**TOWN OF MOUNTAIN VILLAGE
REGULAR DESIGN REVIEW BOARD MEETING
THURSDAY JULY 11, 2019 10:00 AM
2nd FLOOR CONFERENCE ROOM, MOUNTAIN VILLAGE TOWN HALL
455 MOUNTAIN VILLAGE BLVD, MOUNTAIN VILLAGE, COLORADO
AGENDA**

AGENDA ITEM 5
PLANNING & DEVELOPMENT SERVICE
PLANNING DIVISION
455 Mountain Village Blvd.
Mountain Village, CO 81435
(970) 728-1392

Case Summary: The Town of Mountain Village, working with Tom Umbhau of Bauen Group, is requesting Design Review Board (DRB) Final Architectural and Site Review approval to construct two employee apartment buildings at 415 Mountain Village Blvd, Lot 1001R. The two additional buildings would provide a total of 49 new employee apartments and are proposed to be located adjacent to existing apartments within the Village Court Apartment Complex (VCA). In order to secure approval for this project as designed, the applicant is proposing a concurrent application process for Design Review, Density Transfer and Rezone for the creation of an additional 7 units of employee apartment density, and a Variance for the allowed Maximum Building Height. In order to provide clarity, staff will address the two new buildings in the same manner as the applicant and

5 SECTION AT GRID 5 - (Unit 5) - ROOF HEIGHT ANALYSIS
 H1.00 1/16" = 1'-0"

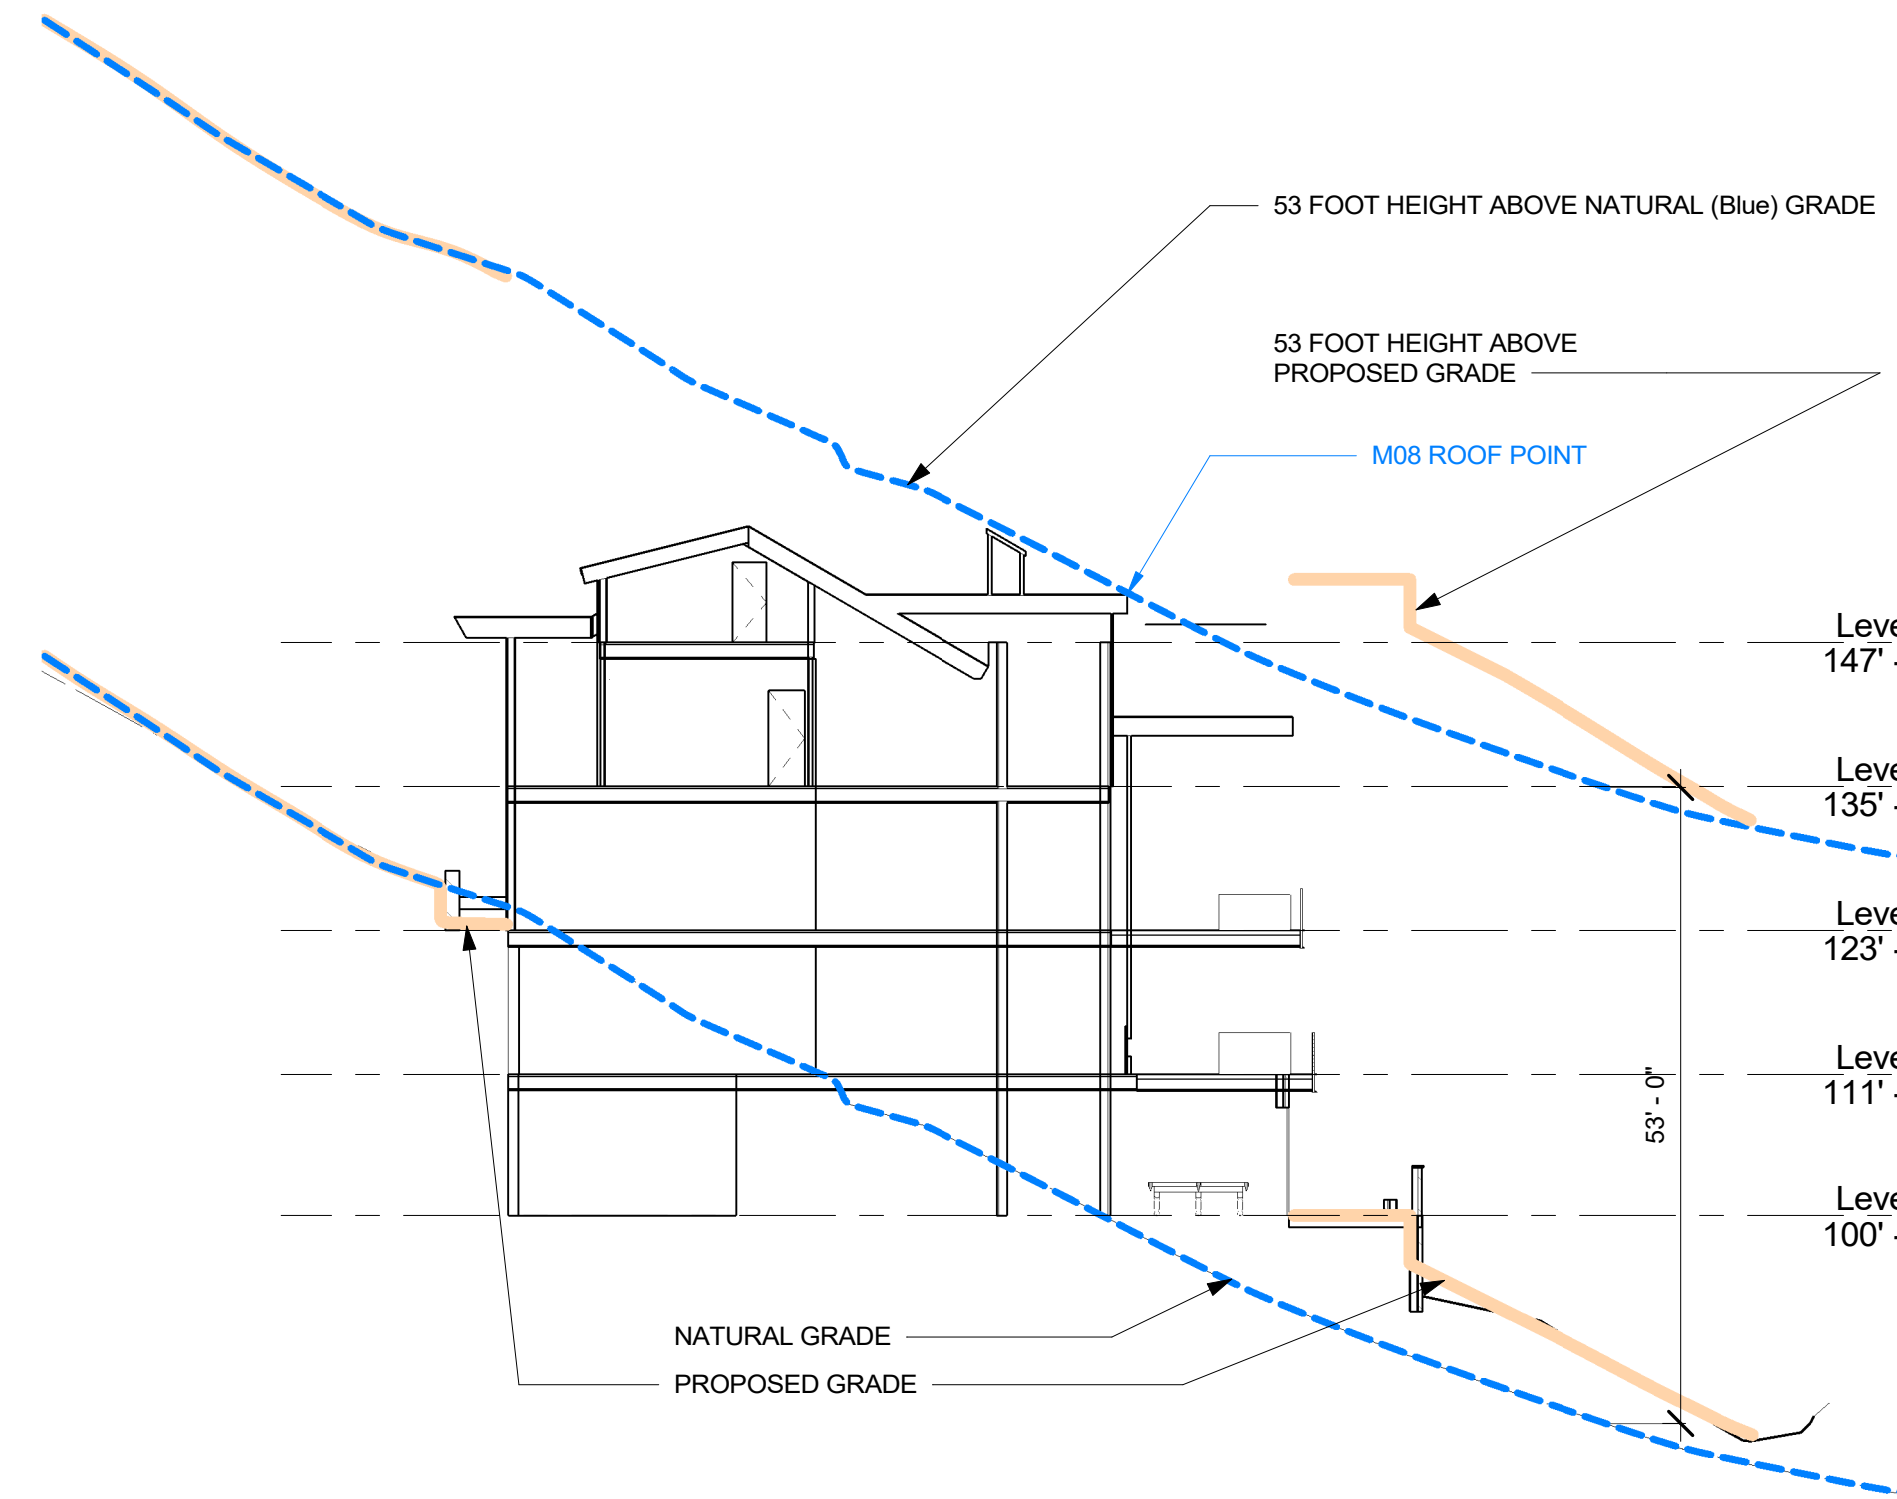
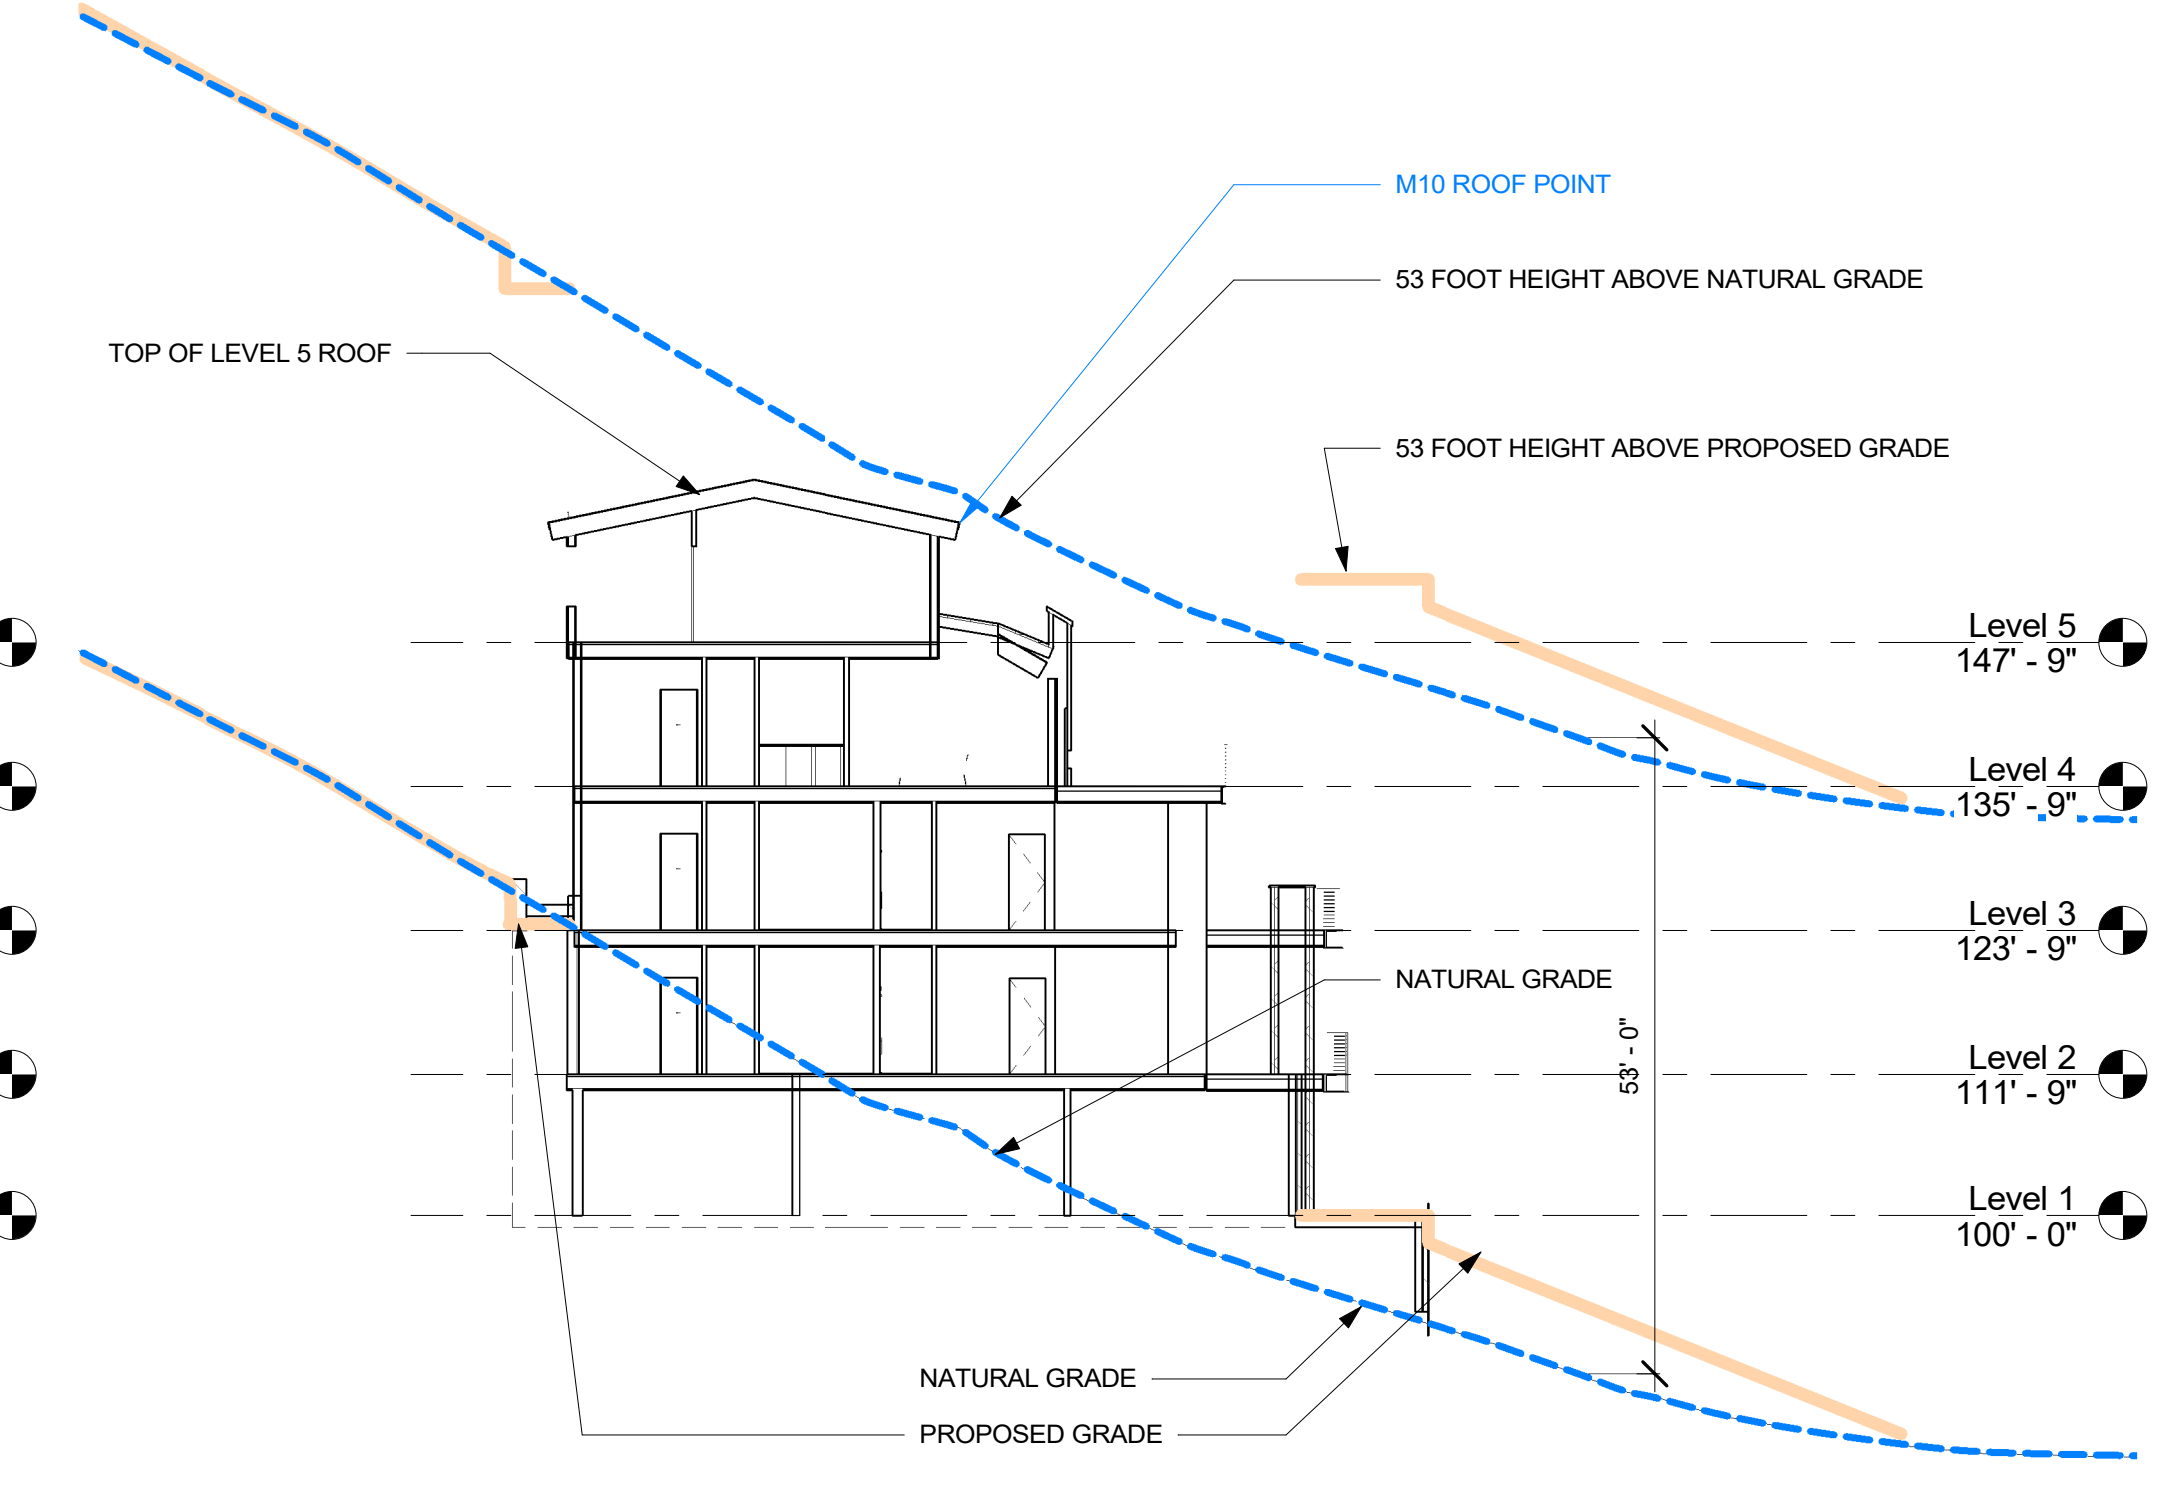
Staff: The applicant has provided a height analysis that demonstrates both Maximum Roof Height Calculations as well as Average Maximum Roof Height Calculations. According to page H1.00 of the plan set, the average height for the proposed designed is compliant at 34.60 feet and the highest point above the most restrictive grade is M08 which has a max height of 52.82 feet. The applicant has provided an average height analysis demonstrating all measurement points above the most restrictive grade, along with elevations demonstrating the height analysis showing a parallel slope analysis demonstrating

PROJECT No.	ORIGIN DATE
20182606.00	11/02/2018
DRAWN BY	CHK BY
TH	PC
SHEET No.	
L1.01	
SCALE: AS SHOWN

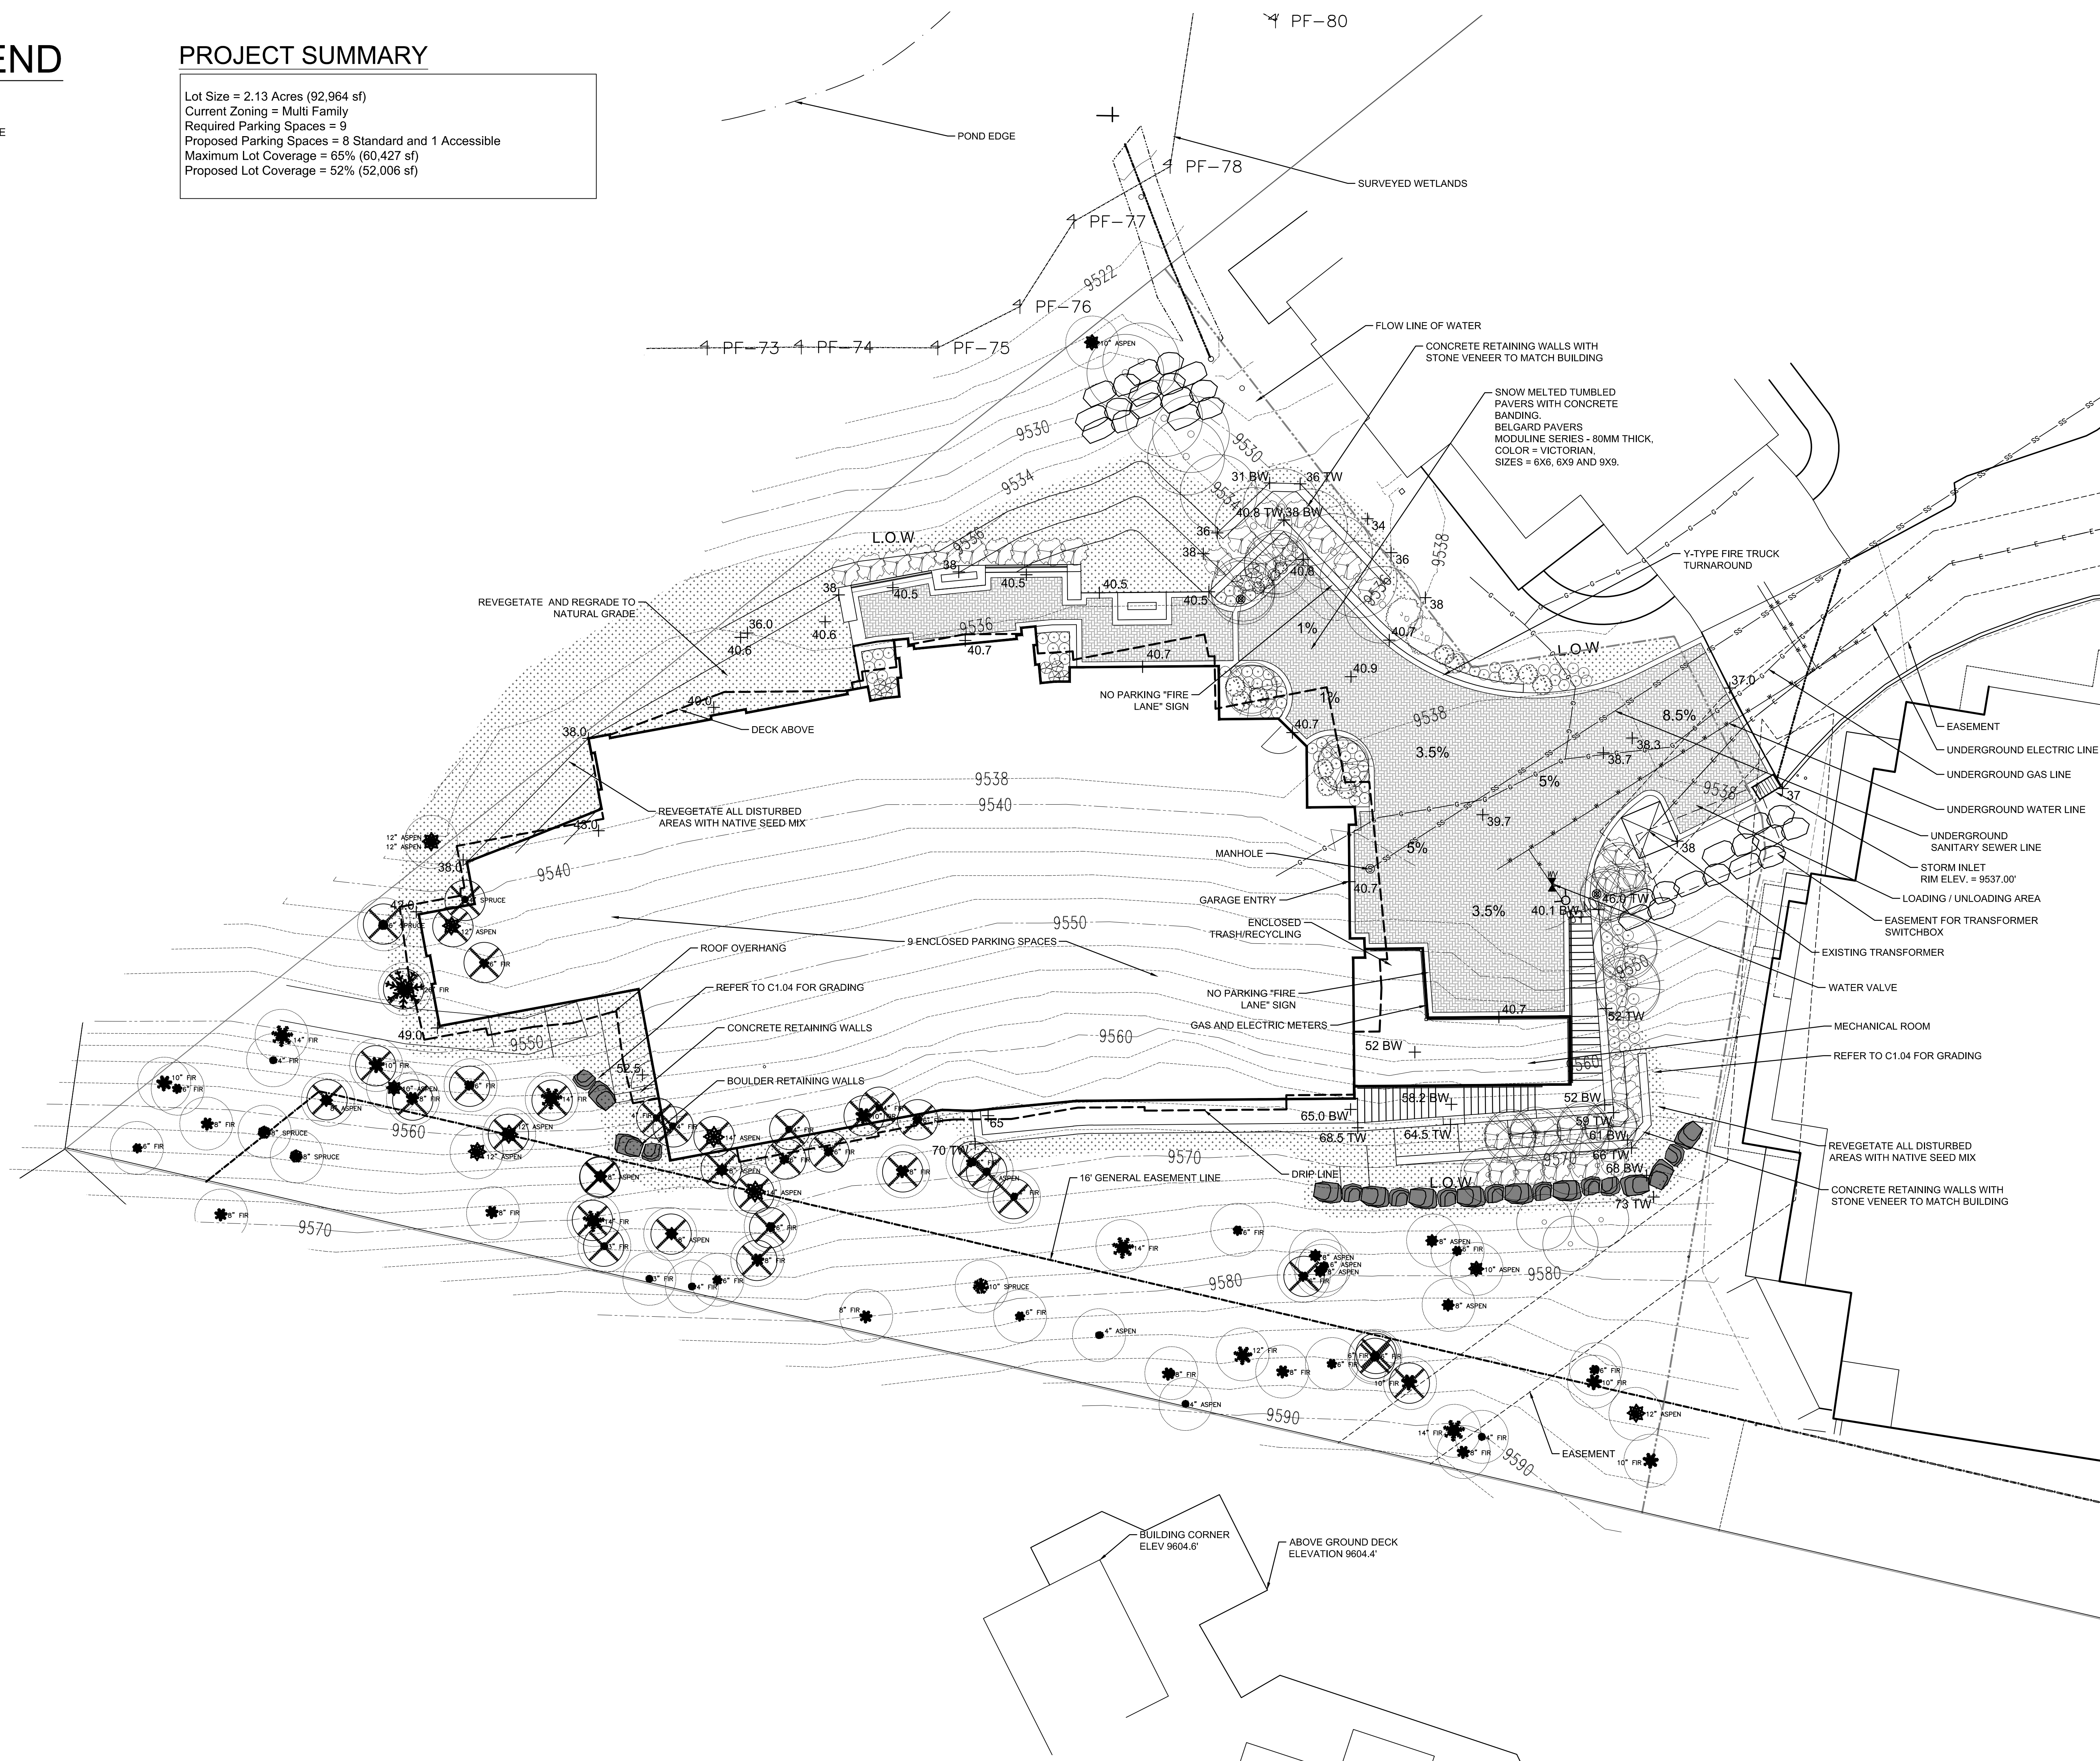
3. Prior to Final Architectural Review, the applicant shall provide a total calculation of exterior areas to have snow melt systems, and revise page L1.01 to indicate those areas in the plan set. *The site snowmelt plan is shown on Sheet M3.5. The total area of snowmelt is approximately 6,525 sq. ft.. The project is allowed 1,300 sq. ft. of snowmelt area which means energy mitigation may be needed for approximately 5,225 sq. ft. consistent with the adopted Building Regulations (We are determining if a boiler was oversized to snowmelt the driveway area of 1,905 sq. ft.). Snowmelt is not regulated by the Design Regulations and is checked by the Building Department with the required building permit process.*
